Technical Bulletin
No: 901 – ESA-10 Remote On/Off Modification

Sample Hook Up:

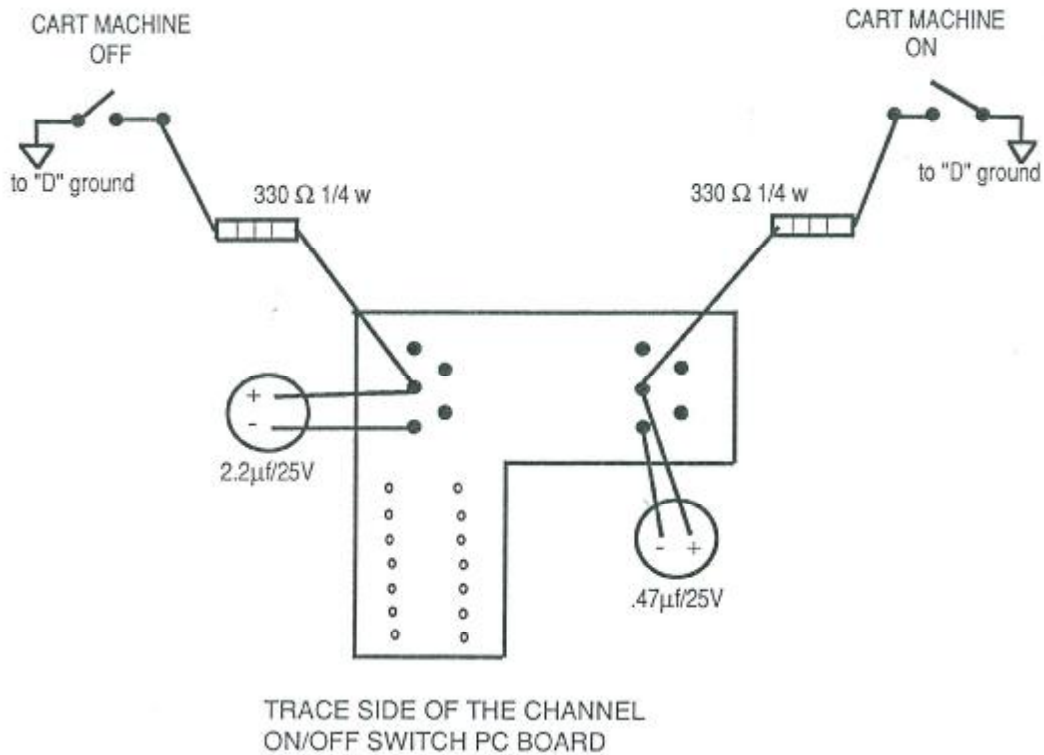
Say that you have 3 cart machines, labeled "A", "B", and "C", and that you will be using them on input channels 1, 2, and 3, and that you will use secondary and tertiary tones to sequence the carts from channel 1 to 2 to 3.

CART A:

Secondary tone is wired to channel 2 "ON"
Tertiary tone is wired to channel 1 "OFF"

CART B:

Secondary tone is wired to channel 3 "ON"
Tertiary tone is wired to channel 2 "OFF"

CART C:

Secondary tone is wired to channel 1 "ON"
Tertiary tone is wired to channel 3 "OFF"
